Trammell Crow Company  
**PACES RIDGE**

REZONING PROPOSAL  
TECHNICAL DATA SHEET

SUBJECT: Specific Site Plan Approval for Kiddie Korner Part of Petition No. 88-24(c) by Trammell Crow Company, Tax Parcel No. 049-271-22

**SITE PLAN AMENDMENT FOR ZONING PETITION 88-24 (c)**

**SITE PLAN**

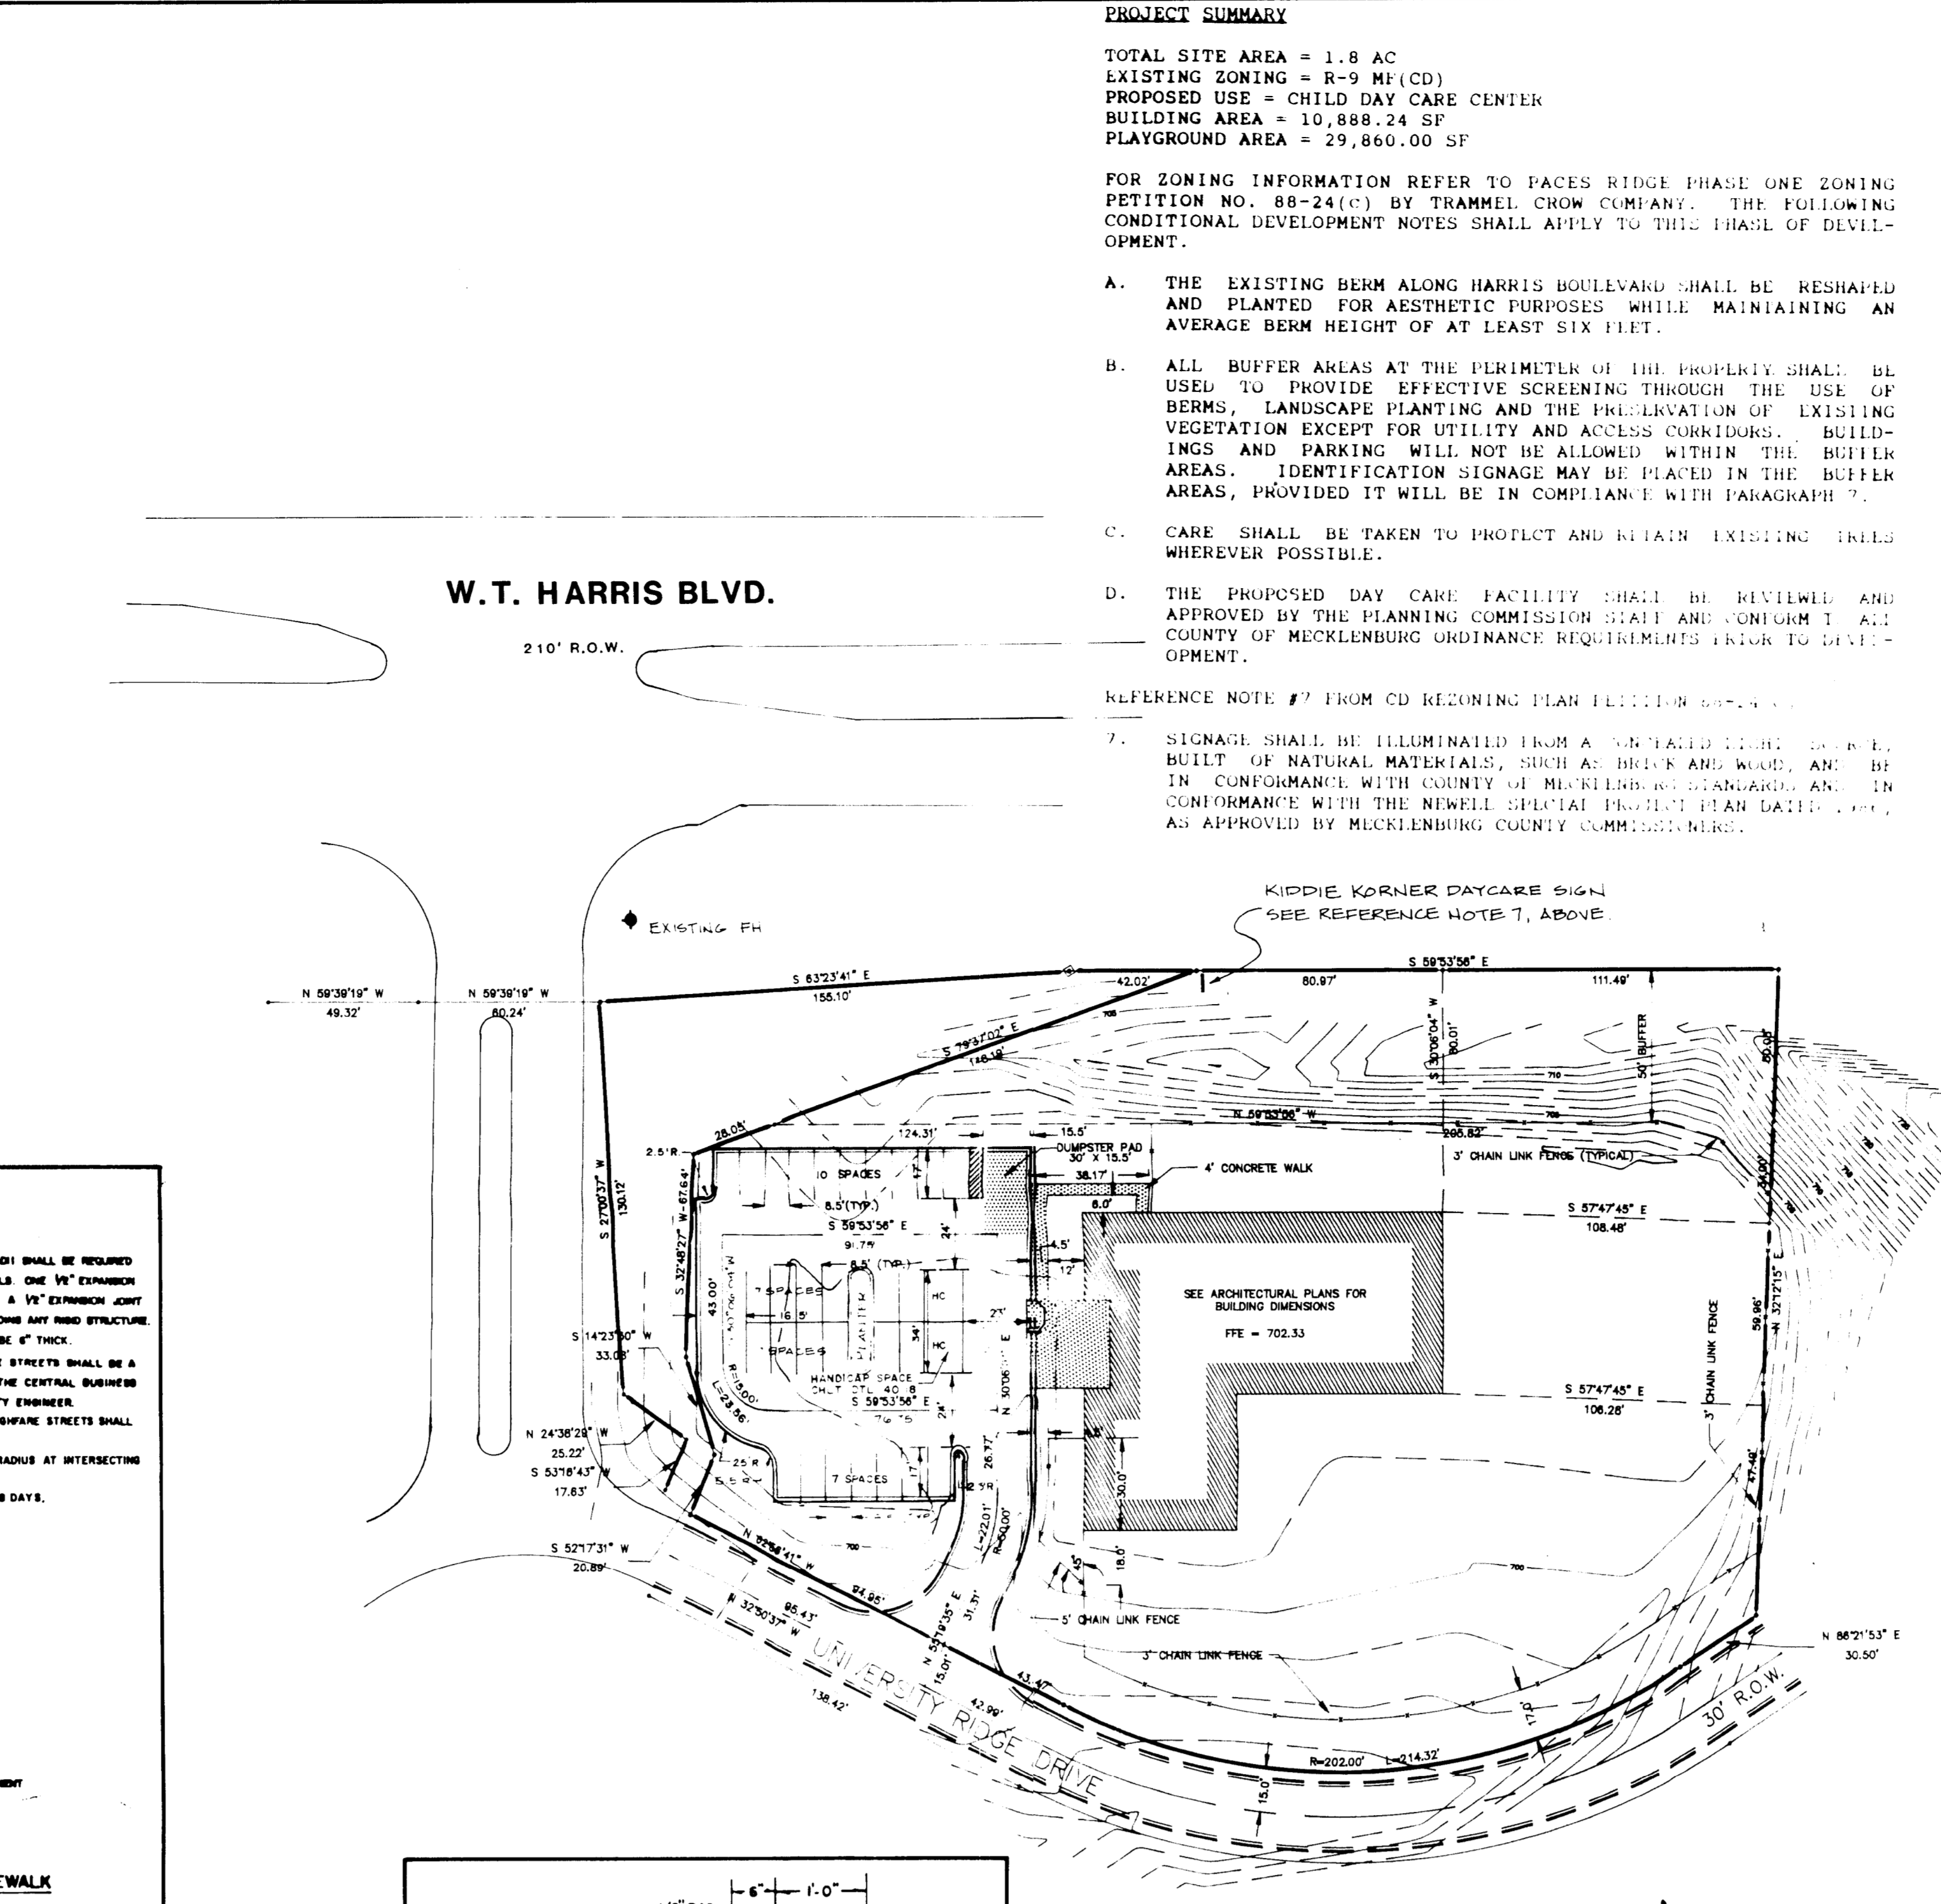
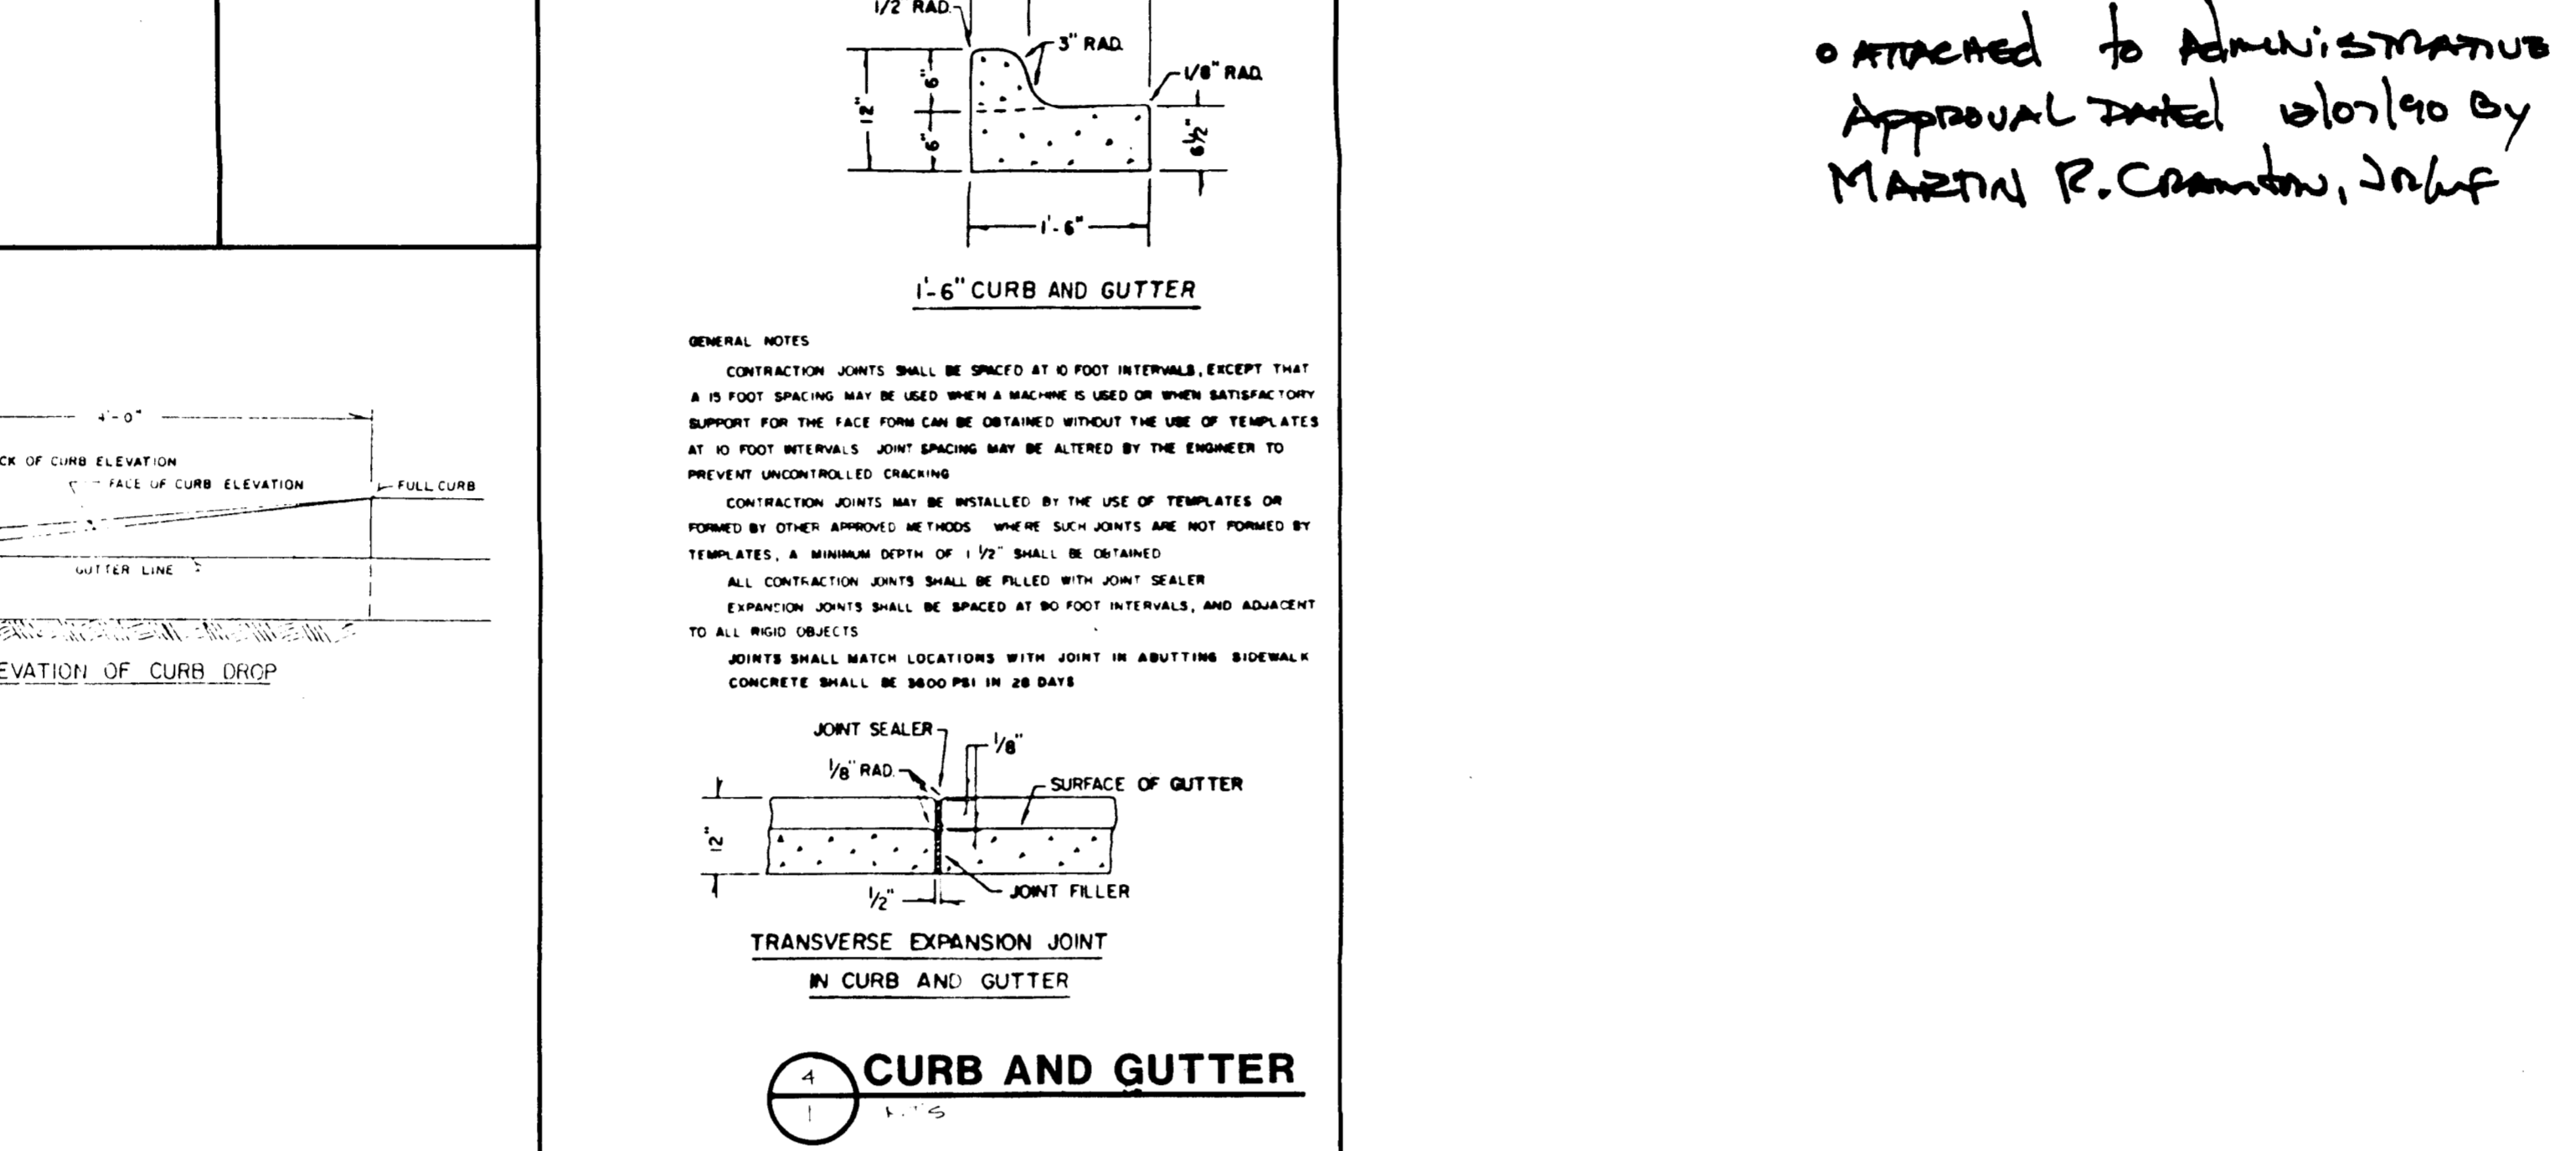
Attached is a specific site plan and landscape plan for the day care center at the corner of East W.T. Harris and University Ridge Drive. We have reviewed this plan against the conditions of the approved conditional plan and find it to be in compliance with these conditions. Please use this plan when evaluating requests for building permits.

**LANDSCAPE AND SCREENING PLAN**

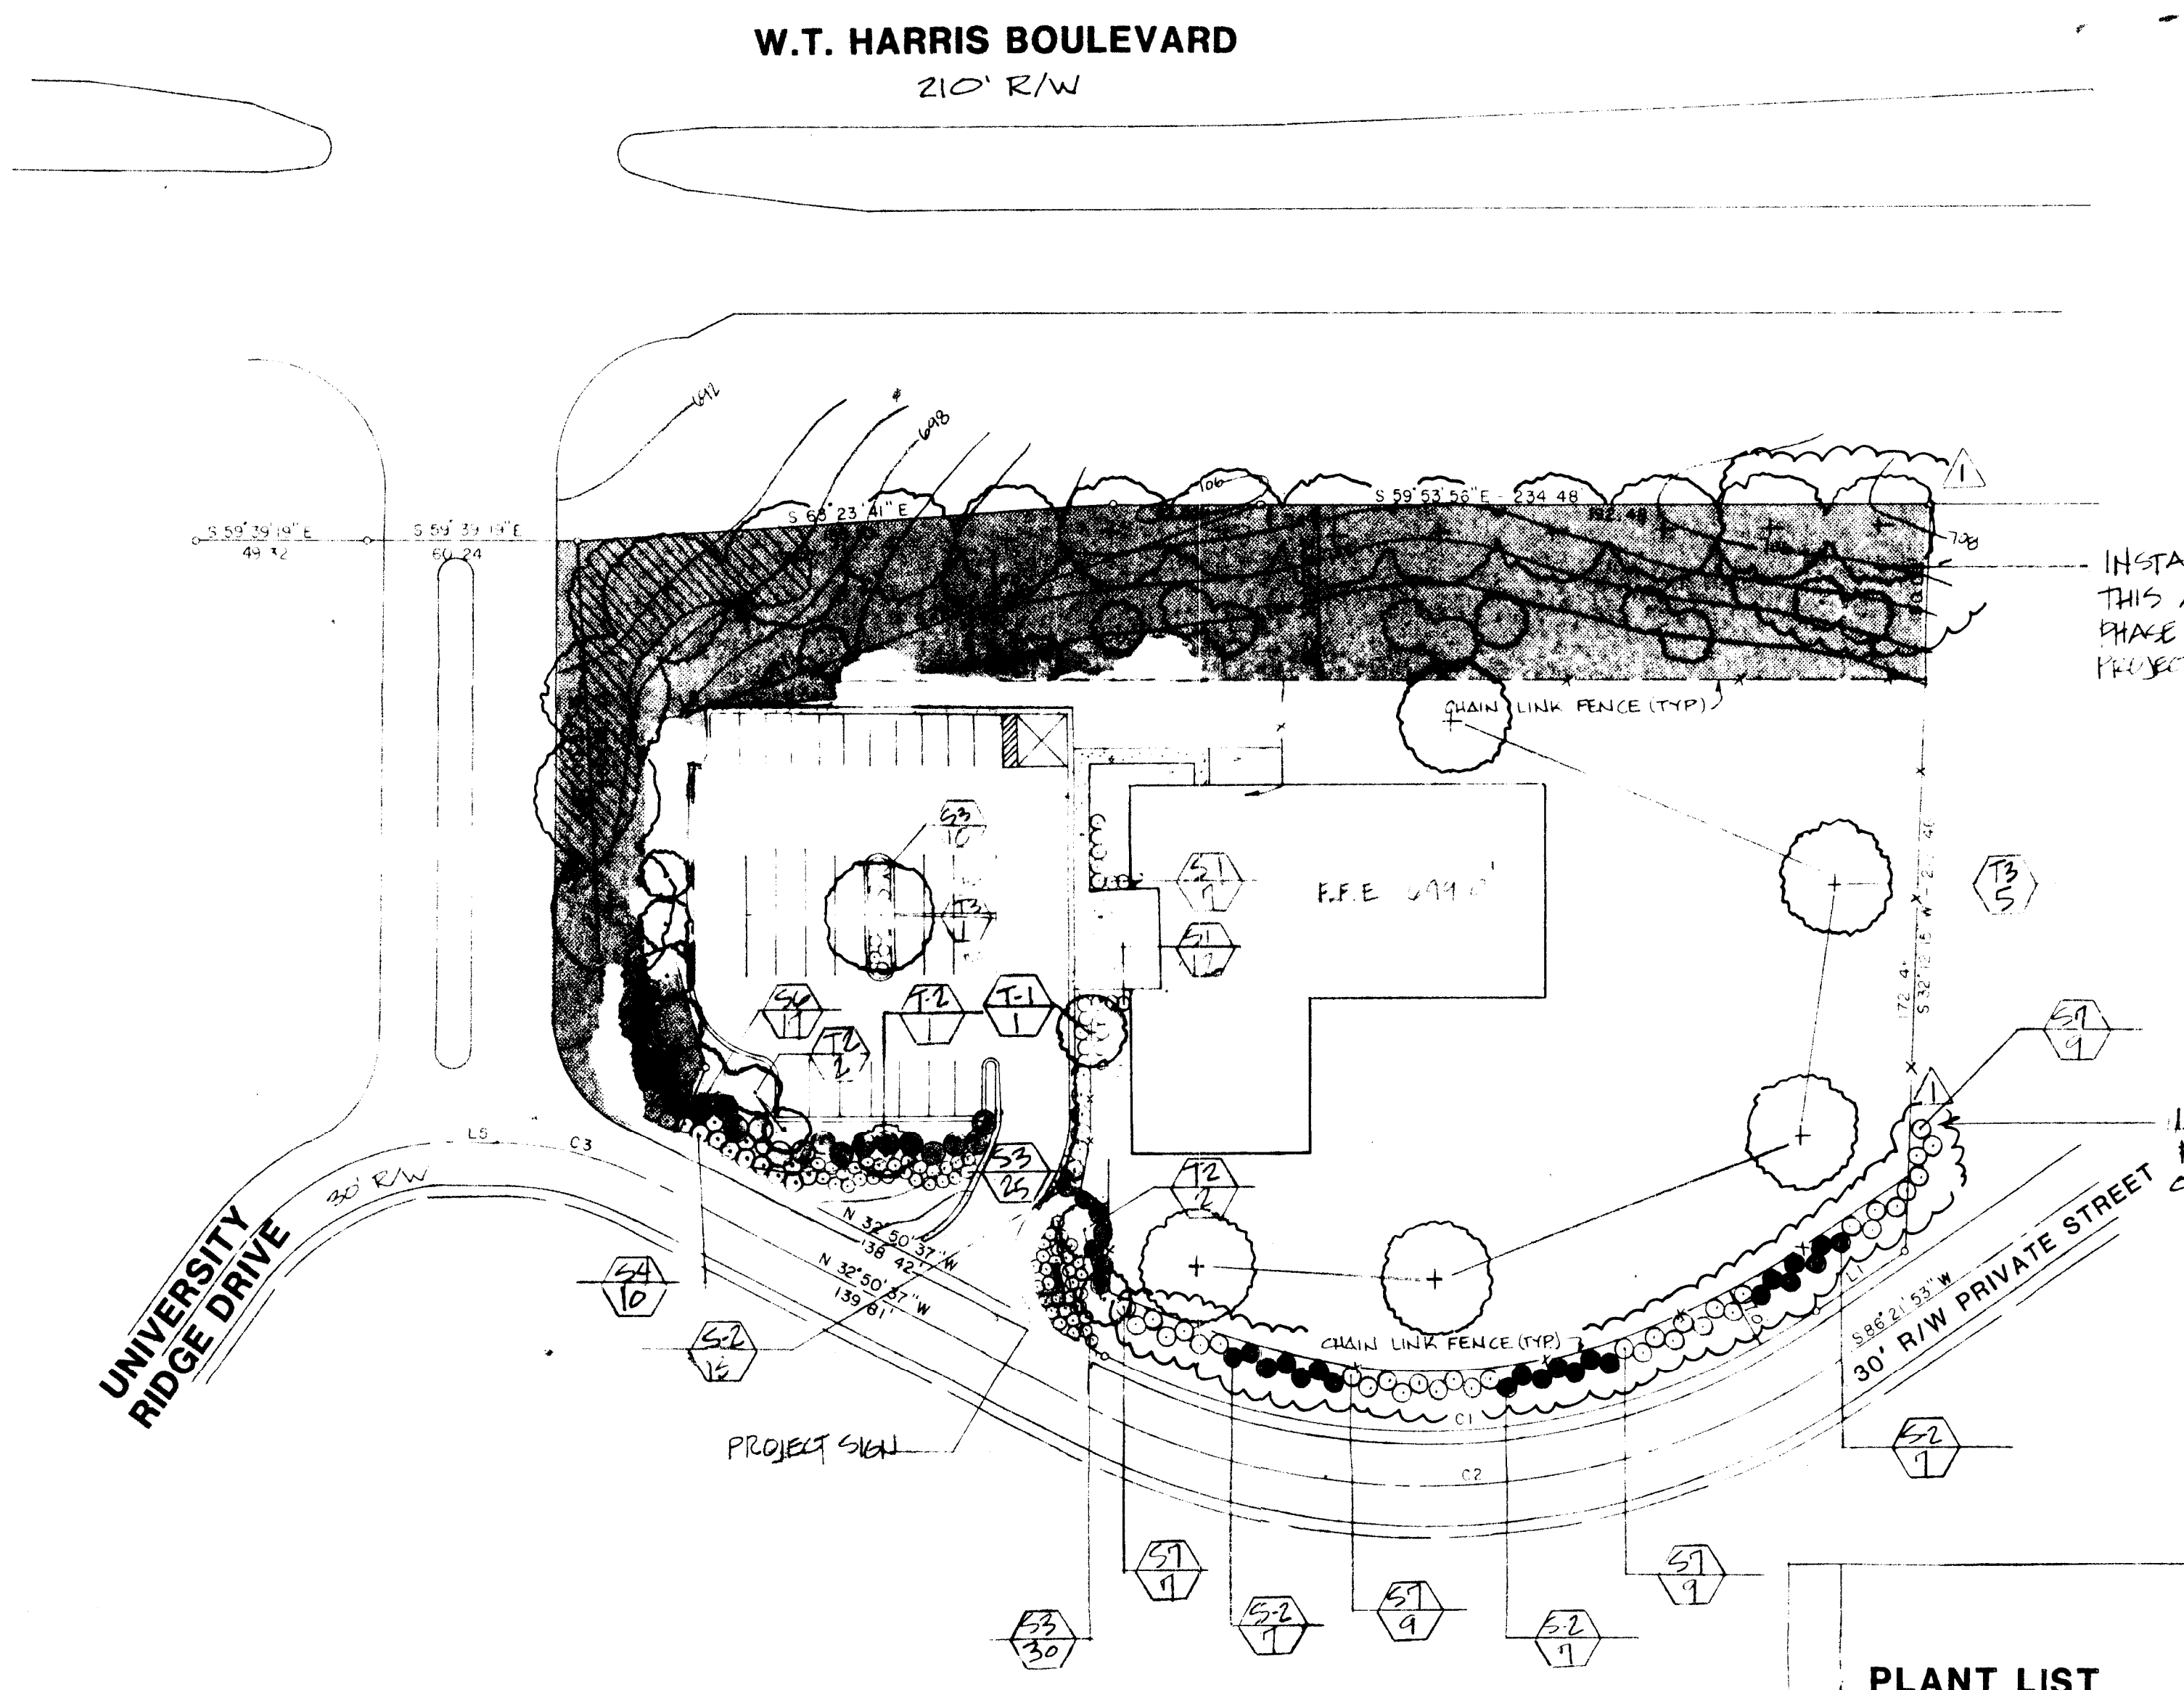
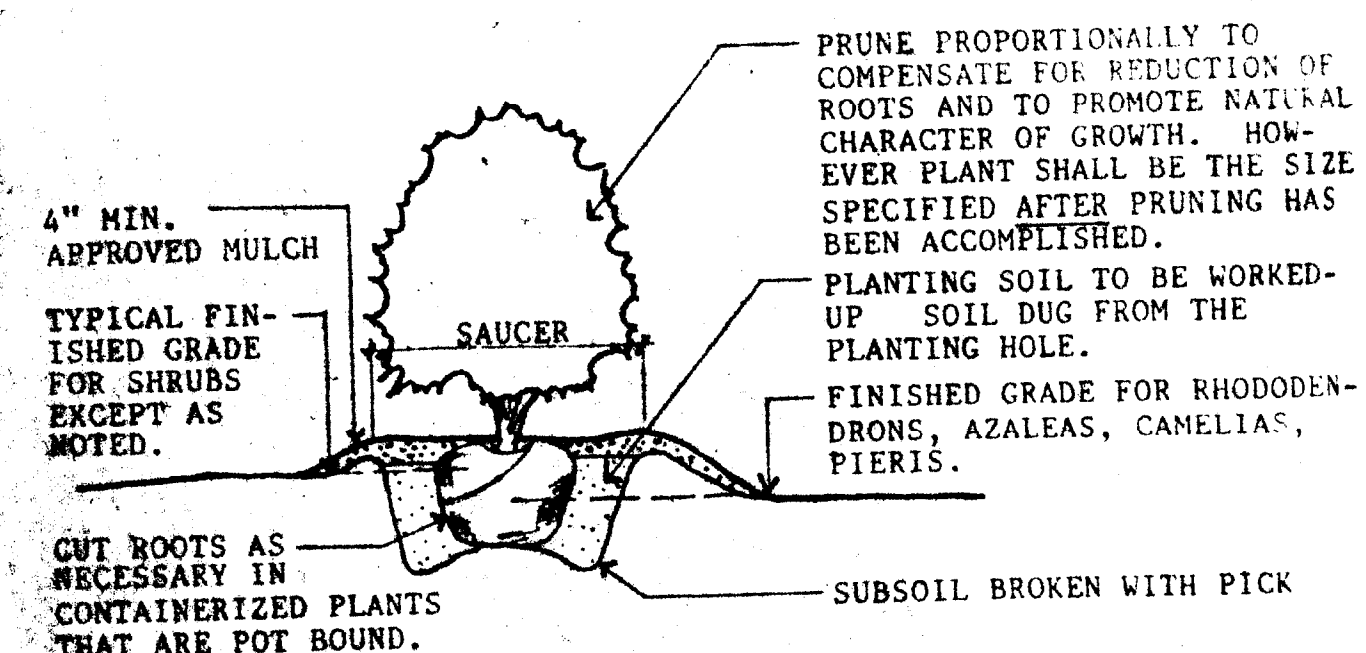
INSTALLATION OF PLANT MATERIAL IN THIS AREA SHALL BE DEFERRED UNTIL PHASE II OF THE UNIVERSITY RIDGE APARTMENT PROJECT

INSTALLATION OF THE SHRUBS ALONG THE FENCE SHALL BE DEFERRED UNTIL PHASE II OF THE UNIVERSITY RIDGE APARTMENT PROJECT

Attached is a revised landscape plan for the Kiddie Korner at University Ridge. The landscape plan has been revised to allow the developer to delete some unneeded plant material and delay the installation of some plant material in two areas of the site until phase two of the adjoining apartment complex is developed. Please use this plan when evaluating requests for building permits and certificates of occupancy.
